### ARCHITECT'S SUPPLEMENTAL INSTRUCTION NO. 6

DATE: March 13, 2024 PROJECT NO: 230117

RE: Streets of West Pryor - Lot 5 Core & Shell

SHEET NUMBER
ME-202

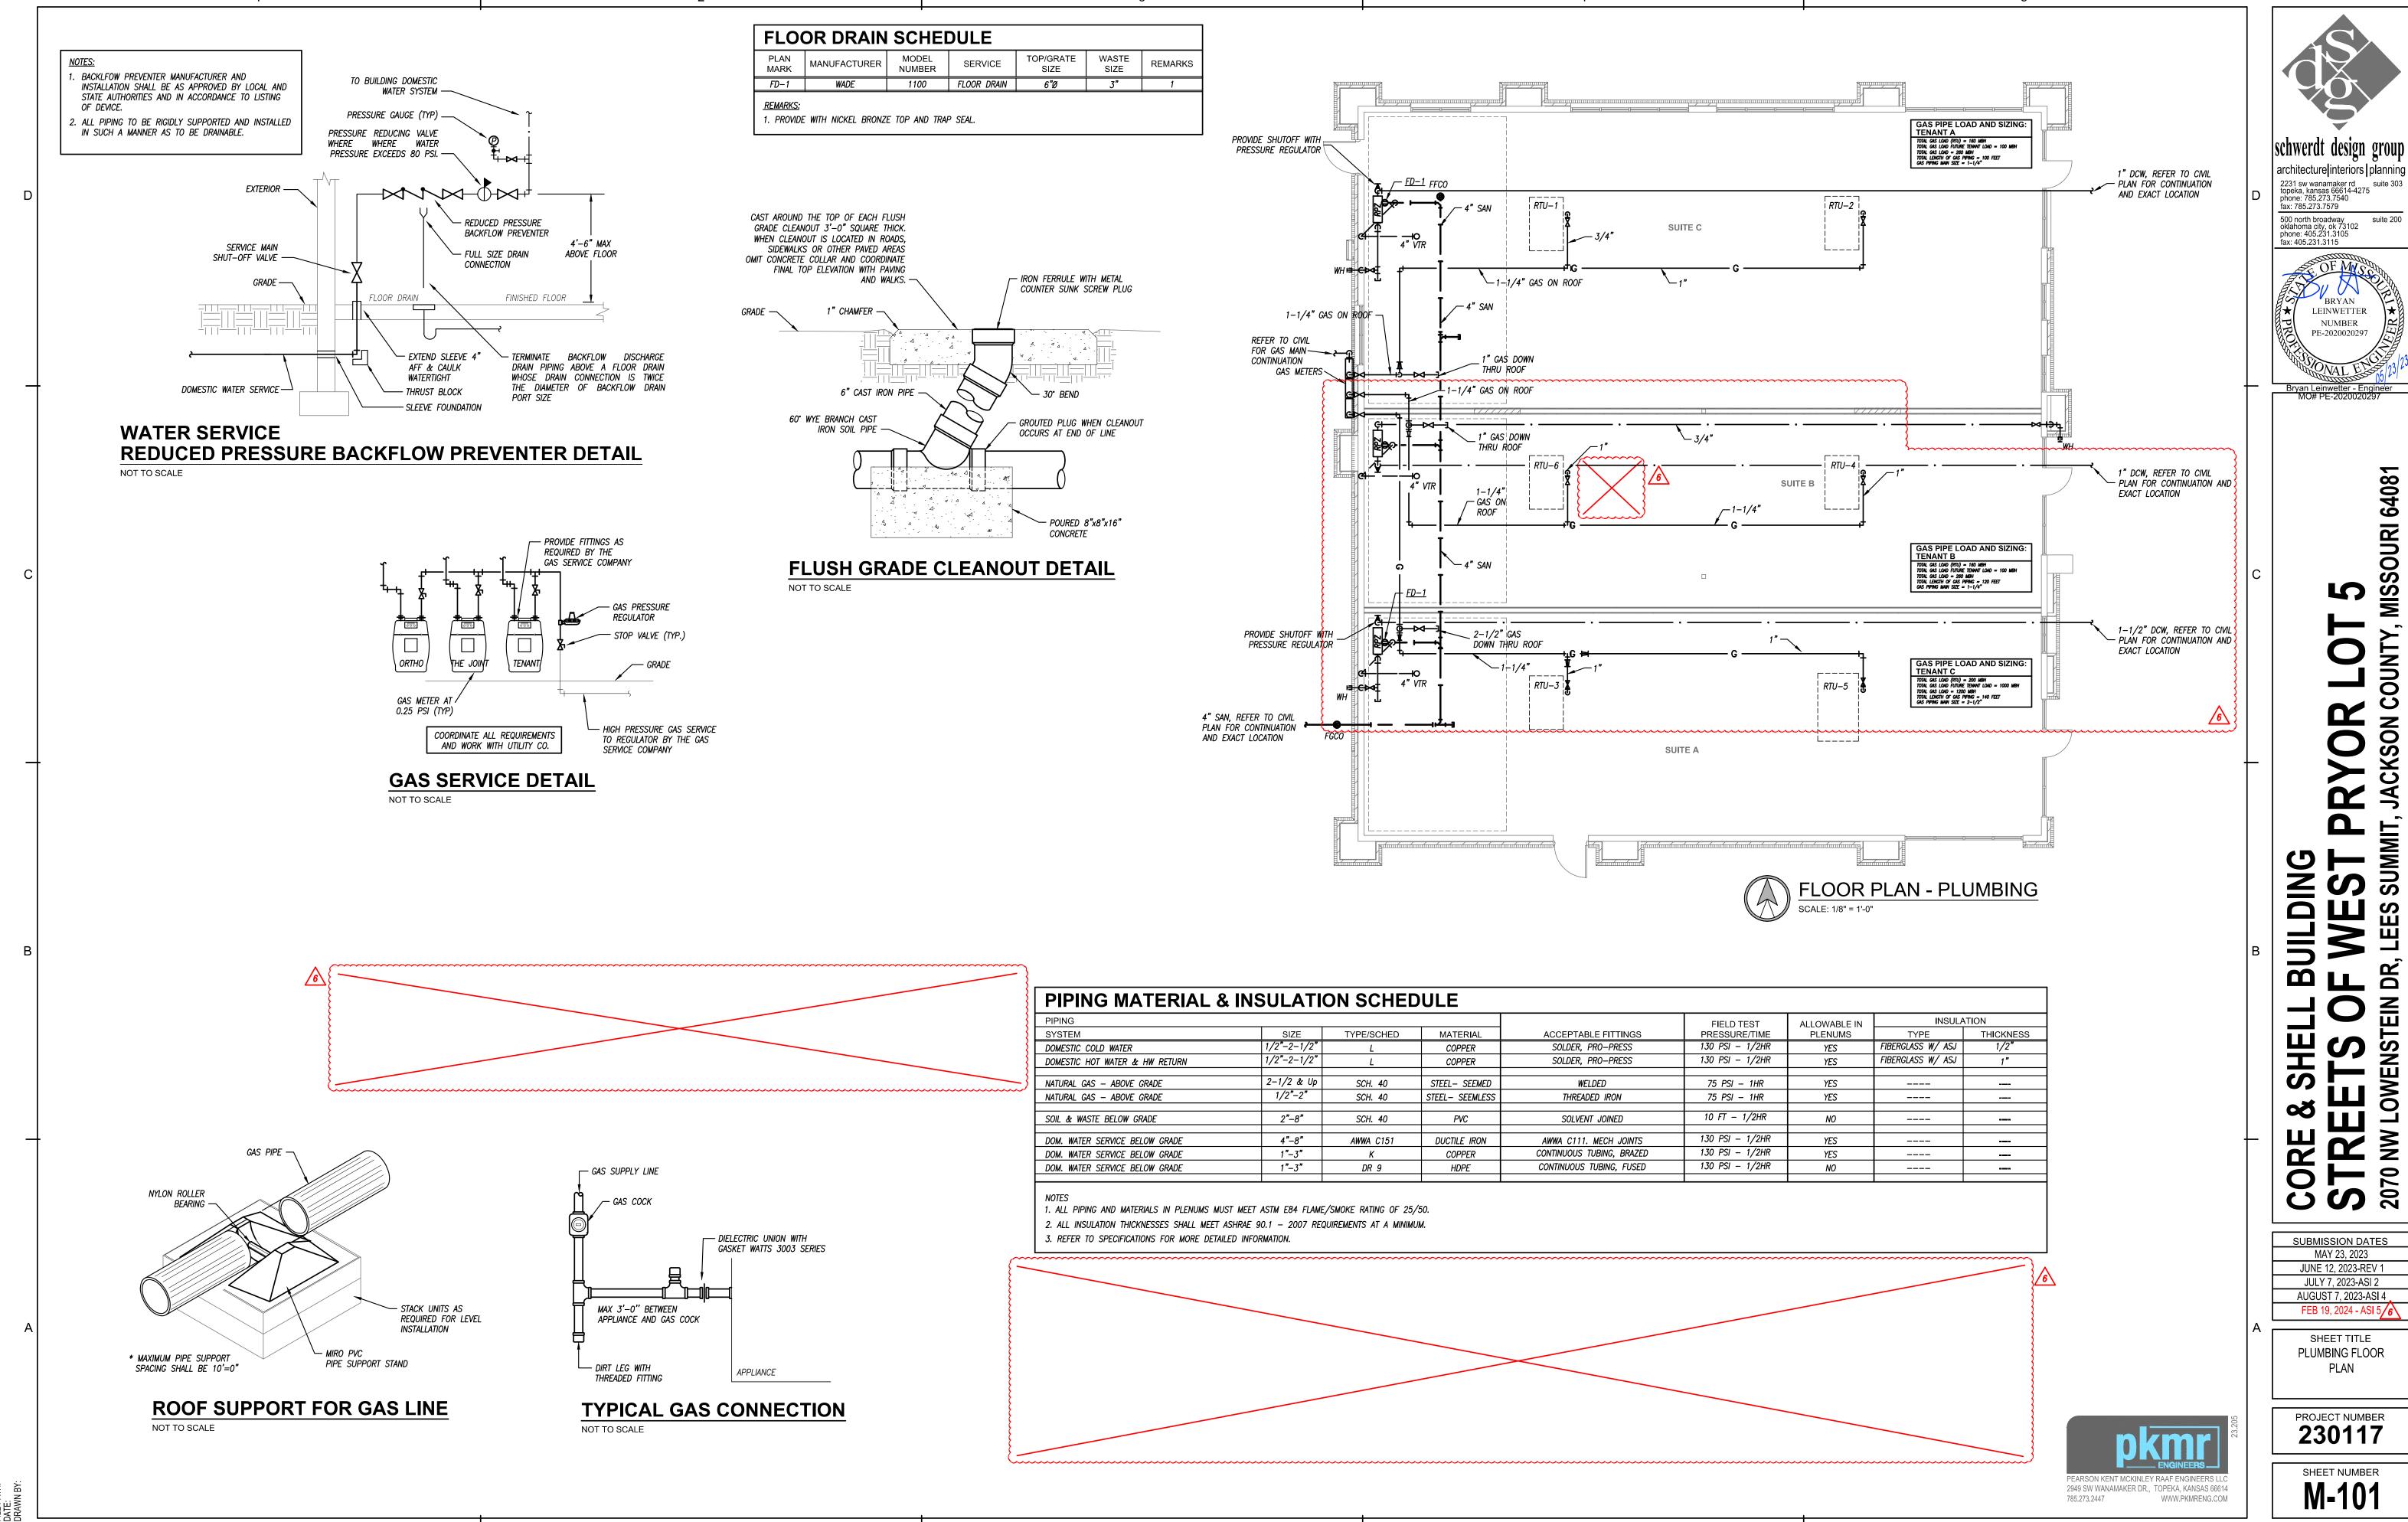
- MEP-1 Sheet ME-201 Updates to Light Fixture Schedule to show "C" fixtures on exterior. MEP-1.A Movement of Light Poles.
- MEP-2 Sheet ME-202 Updated placement of exterior utilities
- MEP-3 Sheet M-101 Swapping the respective placement of RTU 3 and RTU 4 for each other. MEP-3.A Rotation of RTU units
- MEP-4 Sheet M-201 Rotation of RTU units
- MEP-5 Sheet E-101 Swapping the respective placement of RTU 3 and RTU 4 for each other.

SHEET NUMBER M-101

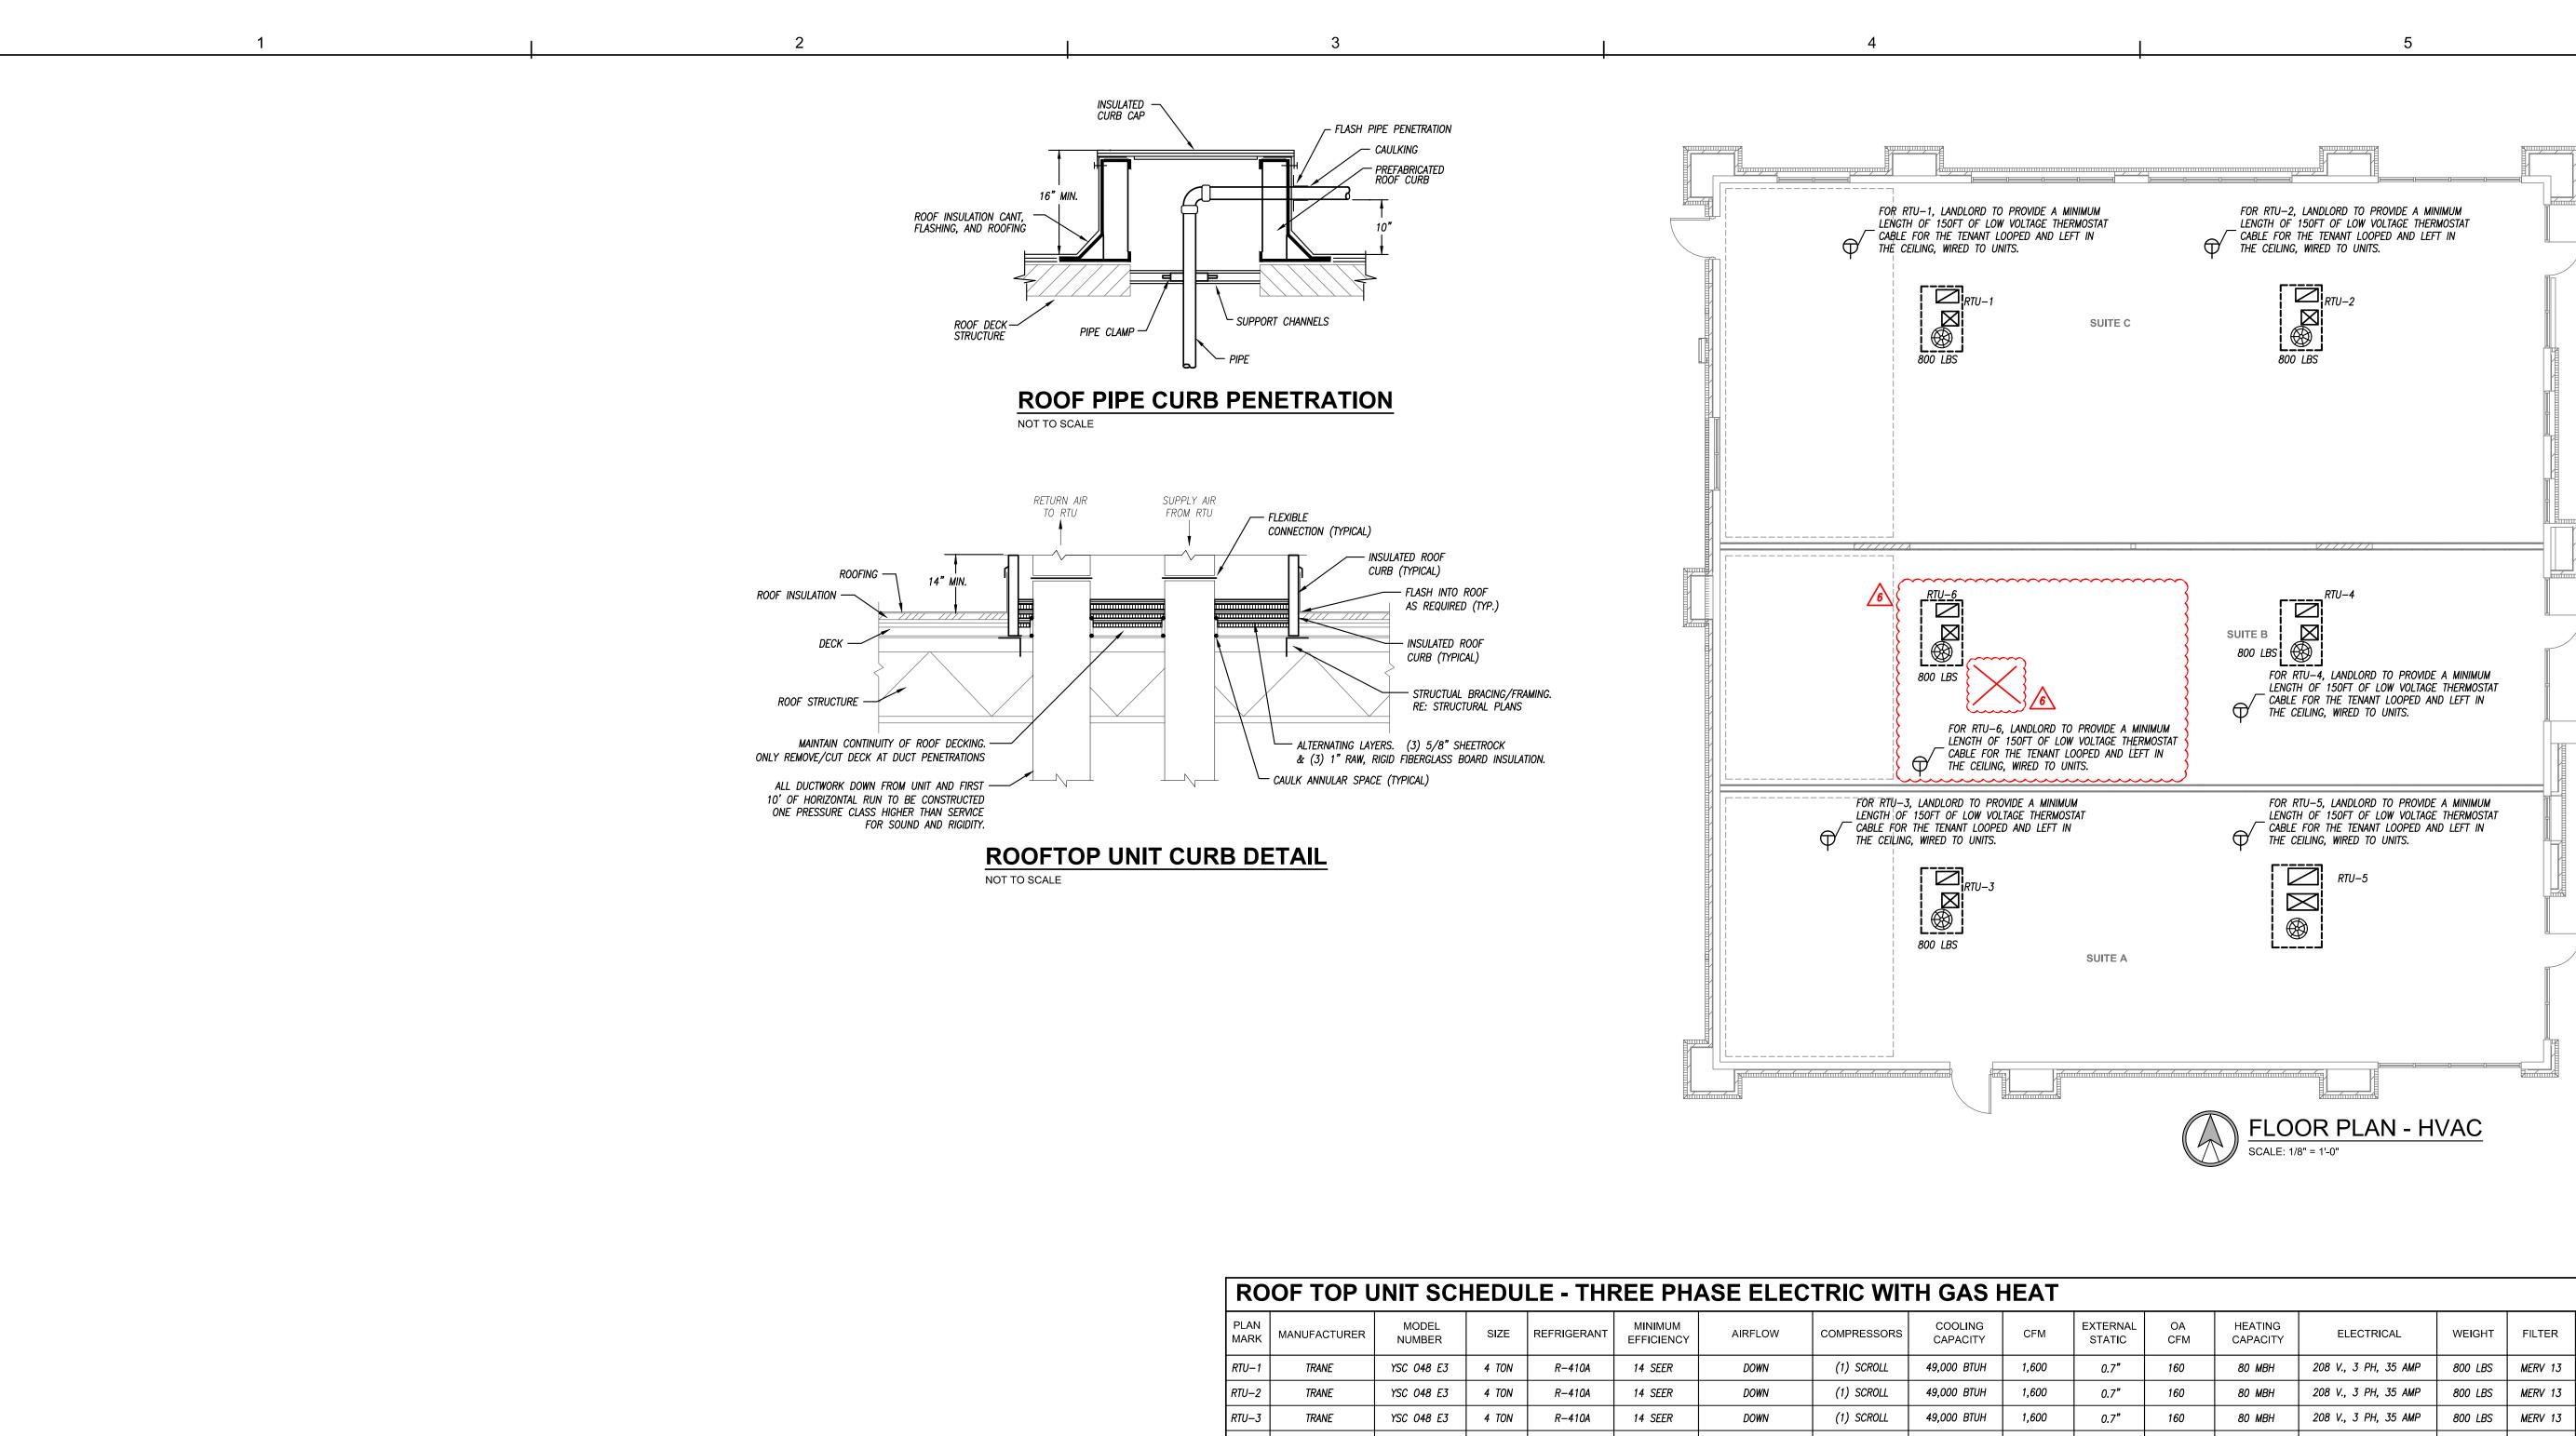
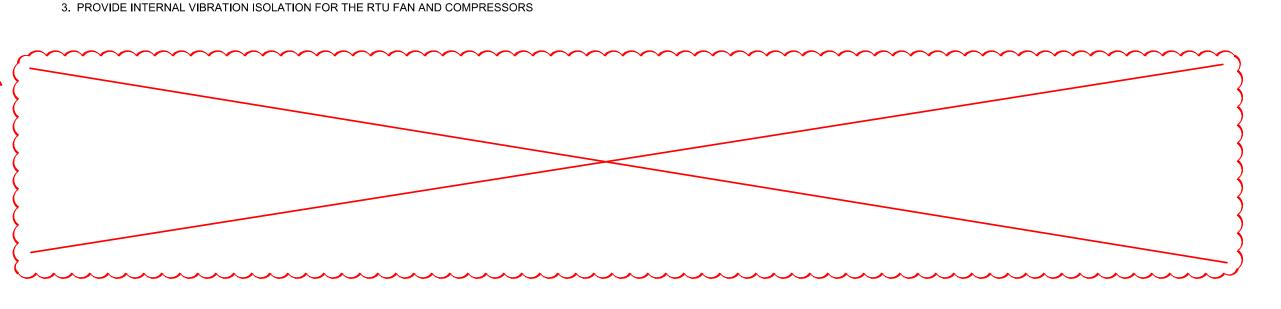
MEP-1 Sheet M-101 – Restroom removed; RTU added to service enlarged Tenant Suite B space.

MEP-1.A Water heater and Plumbing Fixture schedules removed.

SHEET TITLE POWER FLOOR PLAN

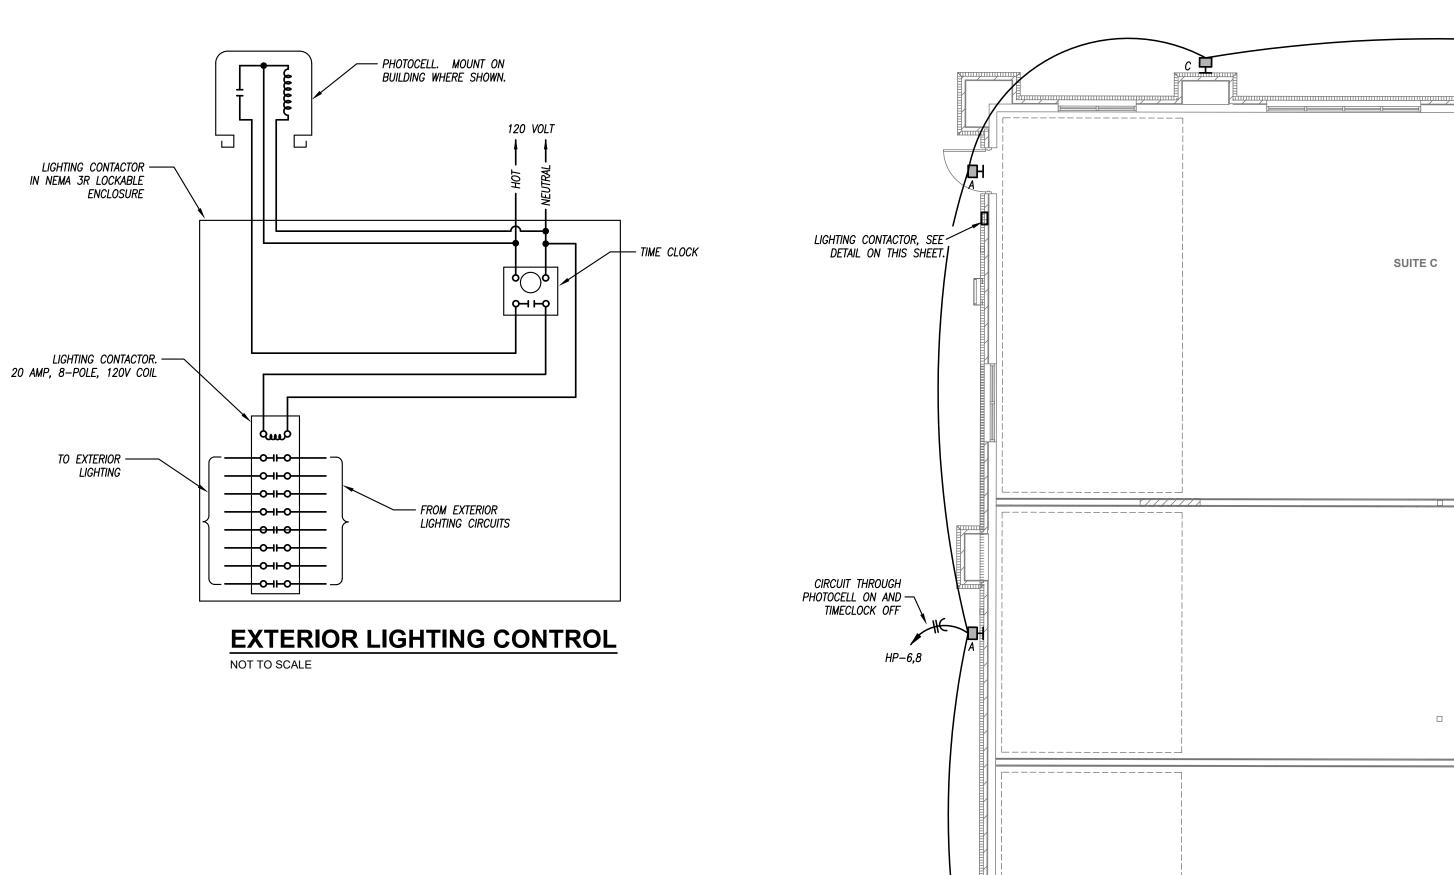
MEP-1 Sheet E-101 – Electrical Riser Diagram updated to two-hundred amp system.

MEP-3 Sheet E-101 – Restroom removed; RTU added to service enlarged Tenant Suite B space.

MEP-3.A Panelboard schedule updated.

MEP-3.B Electrical riser diagram updated with 400A panels.

MEP-3.C Electrical Floor Plan – Power updated for tenant suites A & B.

SUBMISSION DATES
JUNE 12, 2023-REV 1 JULY 7, 2023-ASI 2 AUGUST 7, 2023-ASI 4 FEB 19, 2024 - ASI 5 MARCH 13, 2024 - ASI 6 / 7 SHEET TITLE LIGHTING FLOOR PLAN PROJECT NUMBER **230117** SHEET NUMBER

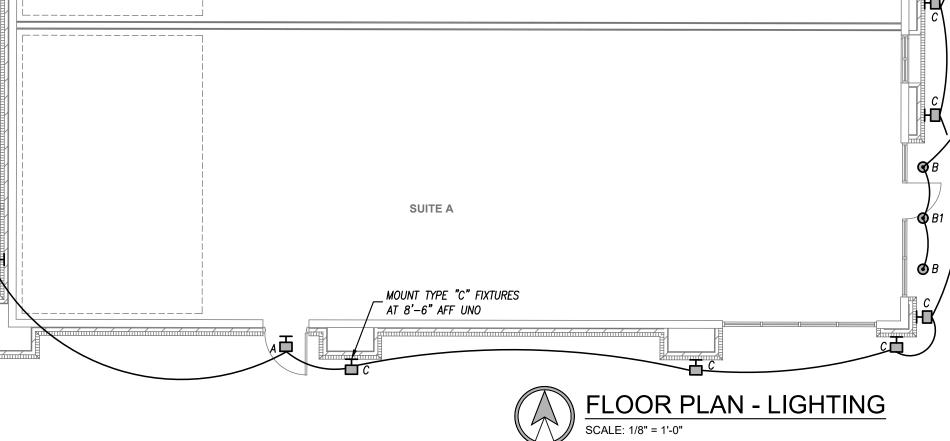
MEP-2 Sheet E-201 – Double-Section Panelboard Schedule updated for two-hundred amp system.

MEP-4 Sheet E-201 – Floor Plan – Lighting updated to three tenant suites A,B & C respectively and Double-Section Panelboard Schedule added to sheet.

MEP-5.B Rotation of RTU units
- MEP-5.C Exterior Utilities shifted south past West wall Pilaster
- MEP-6 Sheet E-201 Mounted exterior lighting updated to "C" fixtures' on floor plan.
